Central Planning Authority

Agenda for a meeting of the Central Planning Authority to be held on **October 25, 2023 at 10:00am** in Conference Room 1038, 1st Floor, Government Administration Building, 133 Elgin Avenue

CPA/25/23

List of Applications Presented at CPA/25/23

Figure 1: Extents of the proposed subdivision outlined in red (Aerial Image Source: UKHO, 2021).

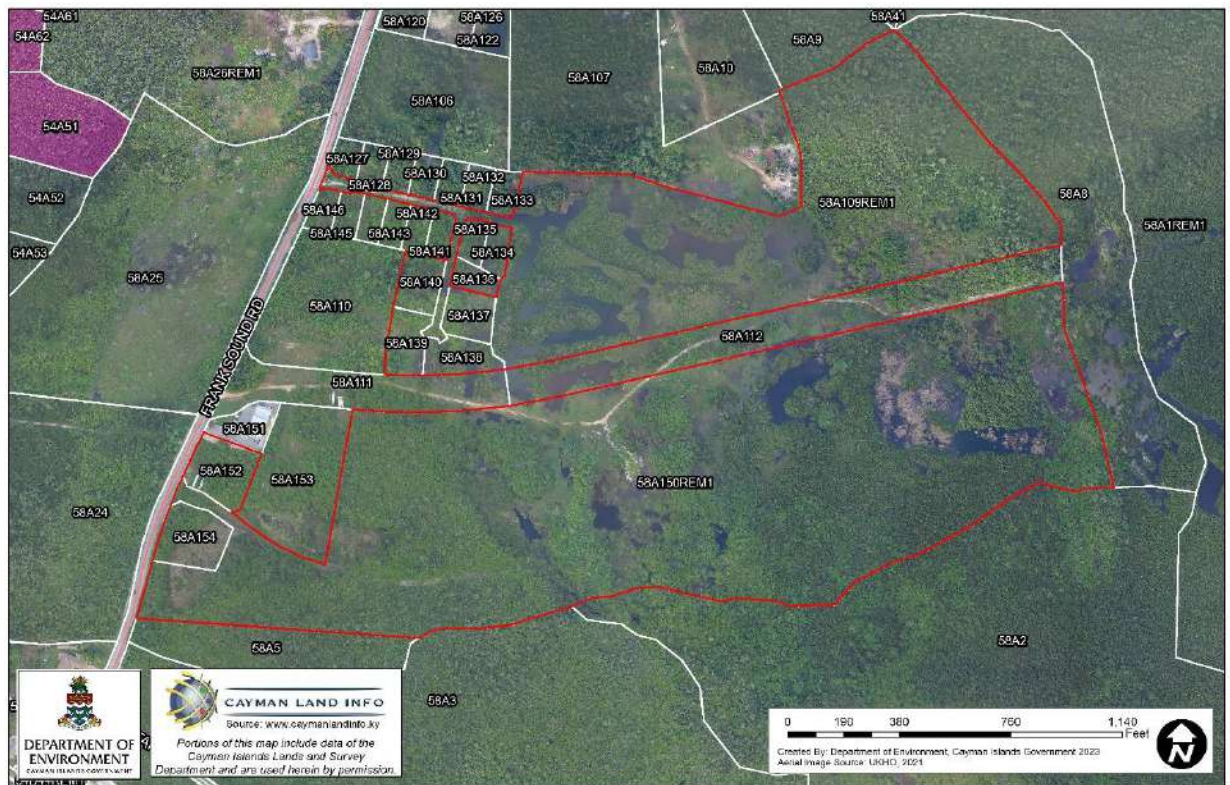
We note that the application is for a subdivision (refer to Figure 1, showing the subdivision extents), we would not support the clearing of the site at this time. Land clearing should be reserved until the development of the individual lots is imminent (through the granting of planning permission for development on those particular lots). This allows the opportunity for the individual lot owners to retain as much native vegetation as possible. Clearing the entire site prematurely removes the choice from the individual lot owners and removes the value the habitat could provide in the time between the preparation of a subdivision and the development of an individual lot.

If the Central Planning Authority or Planning Department is minded to grant planning permission for the proposed subdivision, the DoE recommends the inclusion of the following condition:

1. There shall be no land clearing, excavation, filling or development of the resultant residential or LPP parcels without planning permission for such works being granted.

Figure 2: Land cover map of the proposed subdivision site (Source: DoE, 2013).

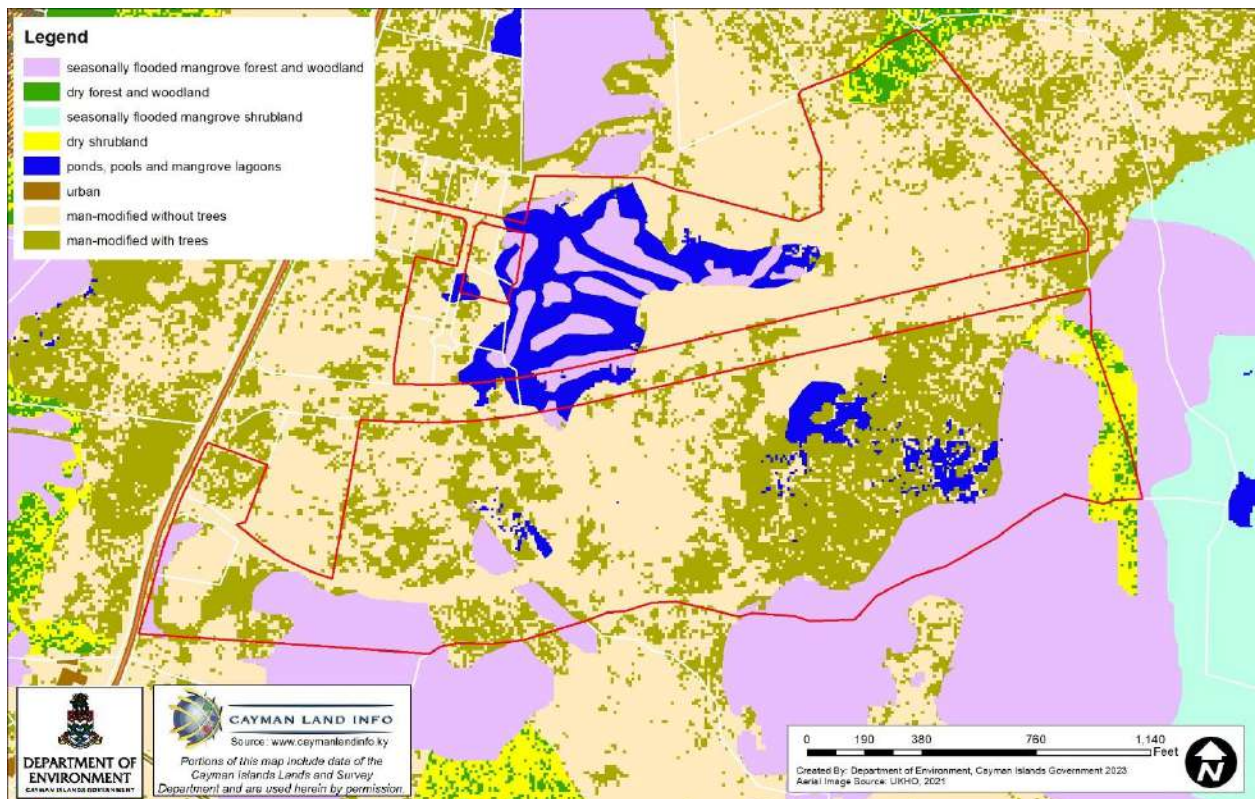
The application site is largely man-modified, although the proposed subdivision contains areas of seasonally flooded mangrove forest and woodland, along with a small portion of primary dry forest and dry shrubland (refer to Figure 2).

The site is extremely low lying, averaging around +3ft Mean Sea Level. The wetland habitat at the center of the proposed subdivision is becoming extremely scarce and there are certain areas which are open water. When development of individual lots comes forward, the majority of the lot would likely need to be filled. At the time of writing this review, the source of the fill had not been identified in the application for planning permission. We recommend that the need for this many subdivision lots be considered along with any artificial demand for fill that it is likely to create. We highly recommend that applicant considers the implementation of a phasing plan, with specific and measurable build out triggers included. This would also allow the wetland habitat to continue to provide ecosystem services until development is imminent.

Figure 3: Extract from the application plans showing the extent of the proposed subdivision and number of lots (Source: Applicant Plans).

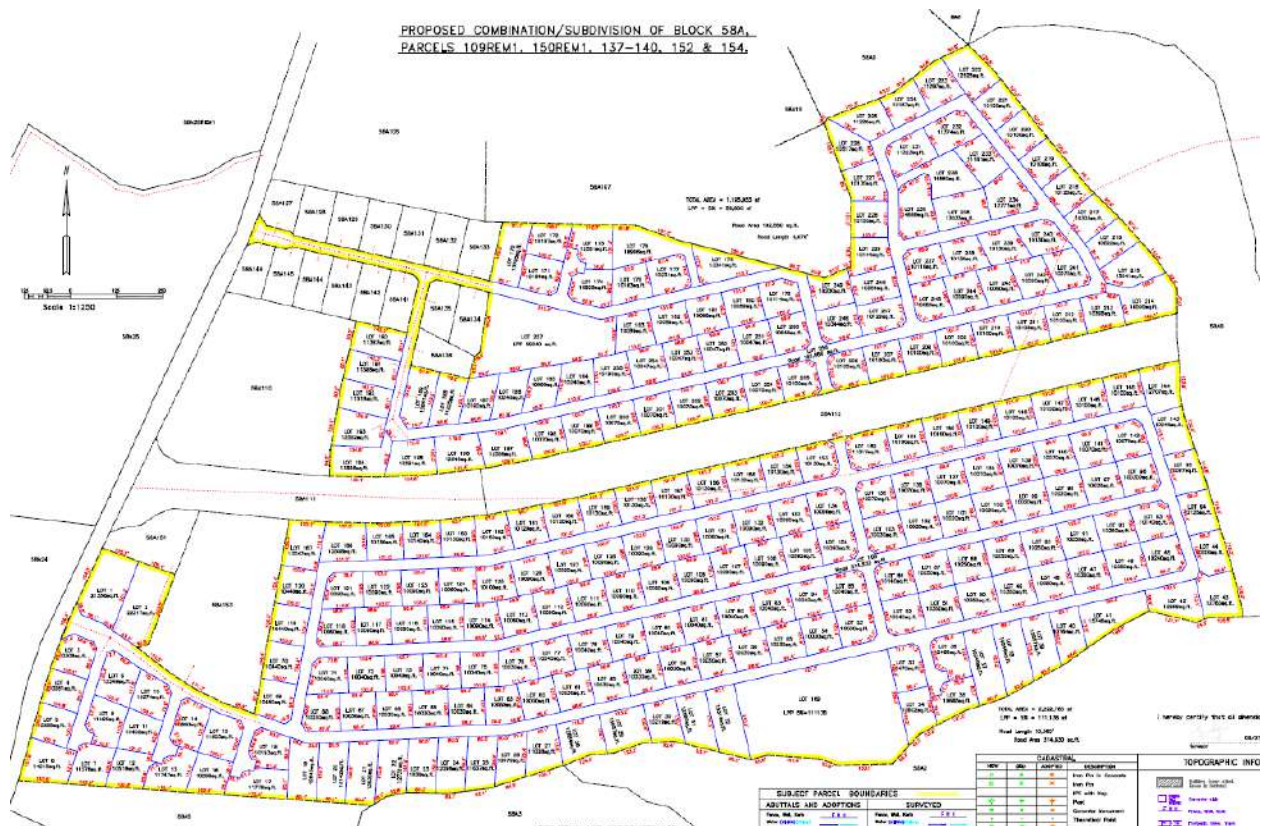
As shown in Figure 3, many lots are relatively small and would be in close proximity to the proposed East-West Arterial with no screening or buffer that would reduce these environmental effects on the residents.

Figure 1: The Application Site outlined in blue, which is located between an existing quarry complex and Meagre Bay Pond Protected Area.

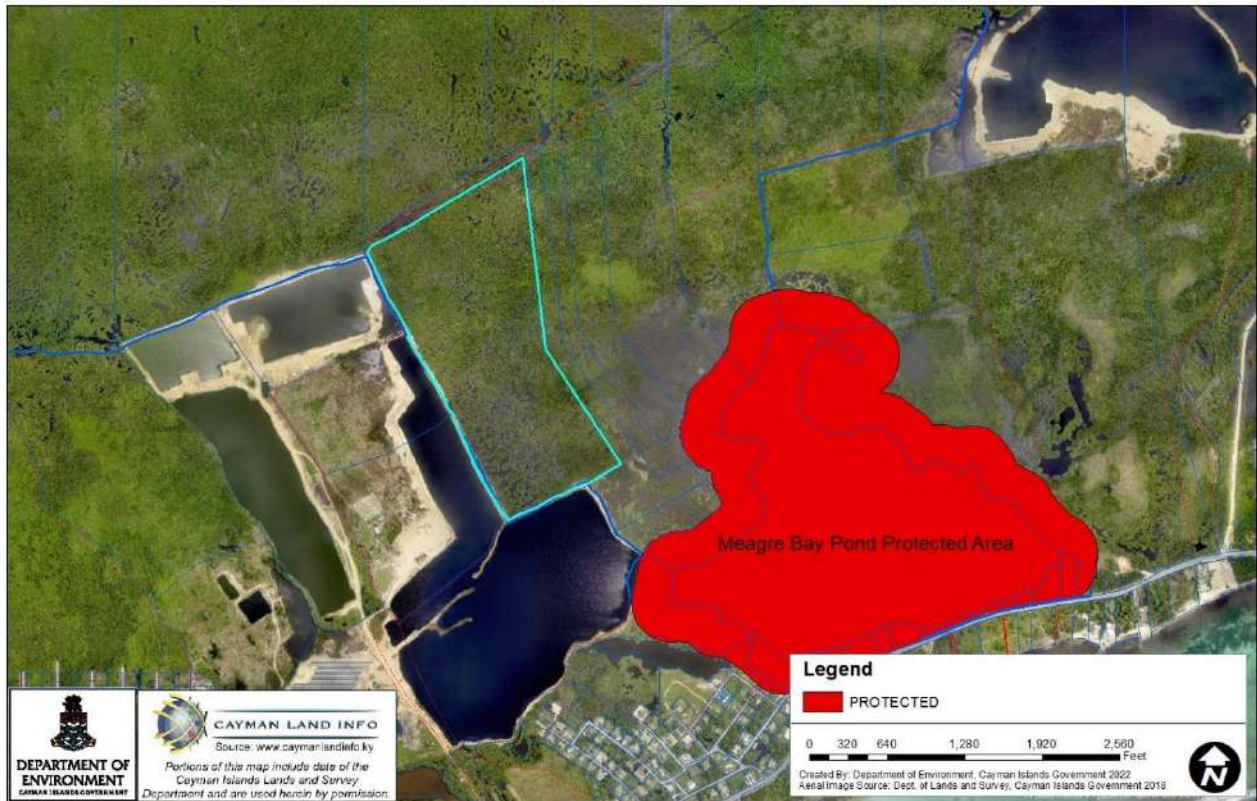
The site is located at Block 43A Parcel 417, located 500 feet north-west of the Meagre Bay Pond Protected Area (see Figure 1). It has an area of 66.4 acres and is characterised by seasonally flooded mangrove wetland. It is contiguous with the Central Mangrove Wetland, forming part of its southern extent. The site is located to the east of a complex of submerged quarries.

It is noted that the Meagre Bay Pond Management Plan was adopted by Cabinet in 2022, which is four years after the EIA Screening Opinion was issued for a nearby quarry application (Maurice Bloom, Block 43A Parcels 419 and

422) in April 2018. Therefore, the regulatory environment has changed and the Management Plan has further outlined threats to the protected area and actions which must be taken to safeguard the pond.

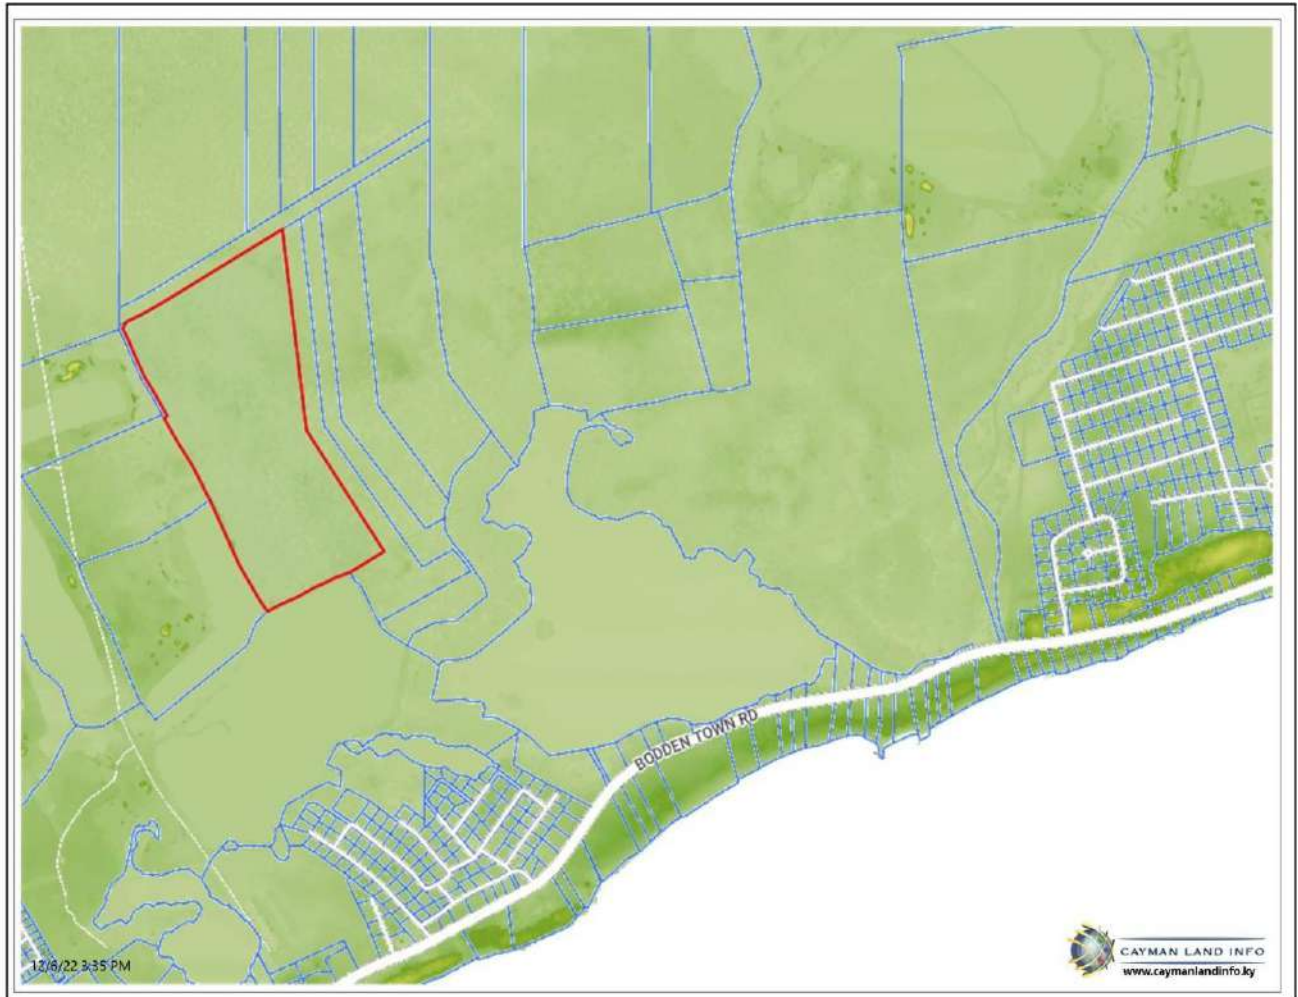
However, the solution to these problems is not as straightforward as including a berm around the proposed quarry. The Department does not hold sufficient information on the hydrological regime of Meagre Bay Pond to adequately predict the effect of the Proposed Quarry. While a berm may address the issue of water overflowing from the quarry into Meagre Bay Pond, it may worsen the ability of Meagre Bay Pond to drain north by blocking water movement across the Proposed Quarry. As shown in Figure 2 below, there is a road and a beach ridge to the south of Meagre Bay Pond, preventing any surface water run-off from travelling south. Although the area to the north of Meagre Bay Pond is at a low elevation, there appear to be dry islands at a slightly higher elevation along the northern shore. These are noted in Figure 2 as subtle dark green islands north of the pond. There are no dry islands at the Application Site and it is probable that this is the easiest path for surface water to flow, allowing Meagre Bay Pond to drain in to the Central Mangrove

Wetland to the north. Therefore, if this area was to become a quarry and the quarry was to be surrounded by a berm, it may cause a significant adverse effect to the Meagre Bay Pond Protected Area.

*As identified in the Management Plan, the existing quarries are already adversely impacting the Protected Area. Given the lack of any environmental consideration or mitigation measures presented in the Applicant's plan, it is highly likely that the introduction of a new quarry may result in new significant adverse effects and may amplify existing risks to Meagre Bay Pond Protected Area with respect to terrestrial ecology and site hydrology. **An EIA is required to address these impacts.***

Figure 2. The proposed pool (blue) and deck (gold) with the parcel boundary (red) and location in reference to a Marine Protected Area (Aerial Imagery Source: UKHO, 2021).

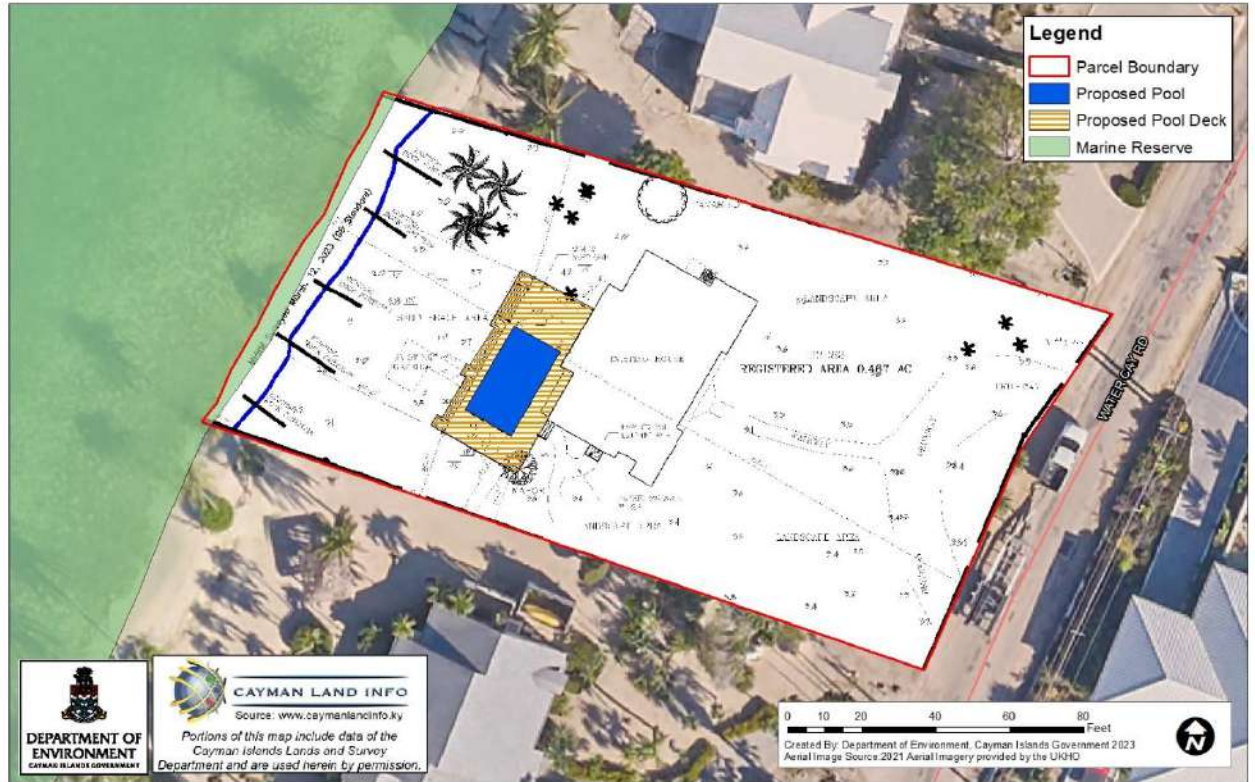
As shown in Figure 2, we note that the setback of the proposed pool and deck falls short of the minimum required setbacks from the registered Mean High Water Mark (MHWM) under section 8(10)(b) of the Development and Planning Regulations (2022 Revision). We note that the proposed pool and pool deck are as close as approximately 50 feet and 42 feet respectively from the MHWM which does not meet the minimum 75-foot coastal setback for beaches required in the Development & Planning Regulations. The Department strongly maintains its stance that coastal setbacks should not be reduced but instead should be treated as a minimum (as prescribed in the Development & Planning Regulations). Setbacks seek to reduce the impacts of storm-related damage upon coastal infrastructure and ensure that development does not encroach onto the “active” part of a beach, as the back beach holds reserves of sand that are critical for sediment supply during periods of storm activity and erosion.

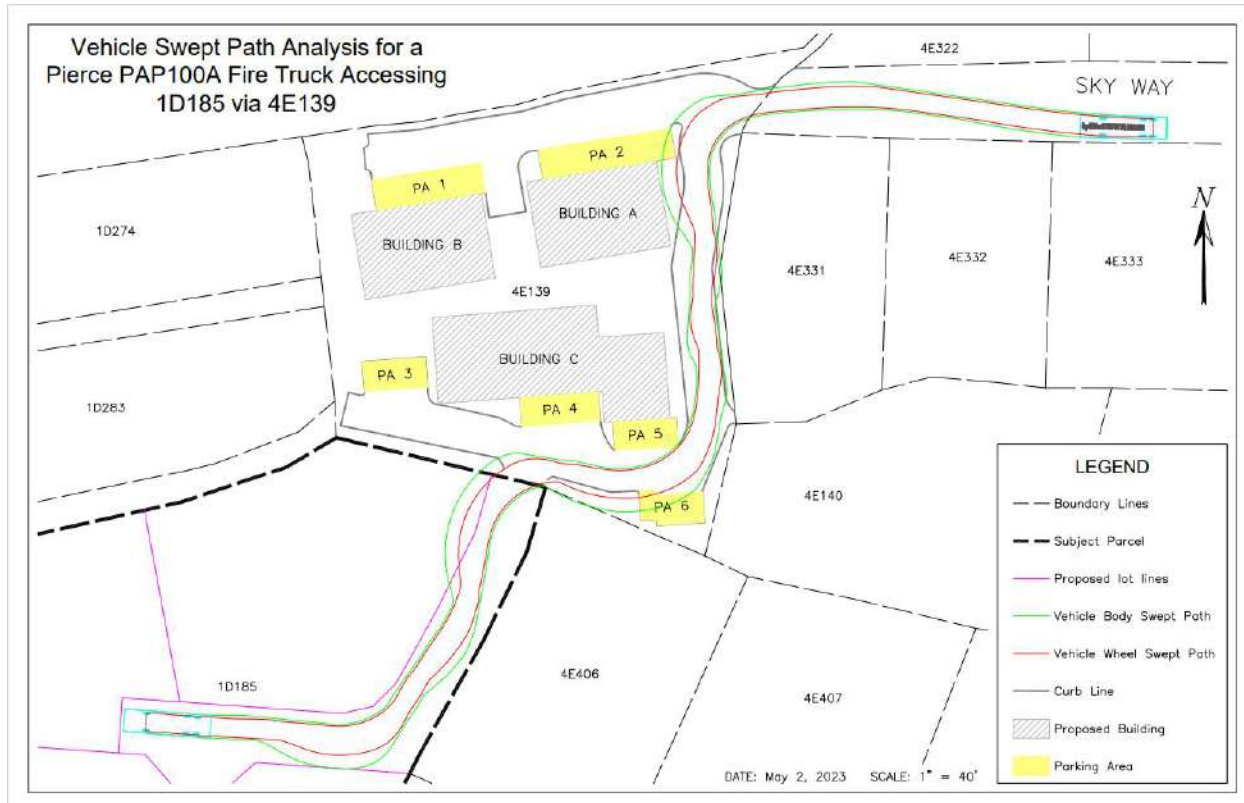
The proposed subdivision does not have access to a public road. The intended access, the right-of-way via 4E139, will need to be built out to the minimum NRA standards for subdivision roads including the drainage conveyance requirement up to Sky Way.
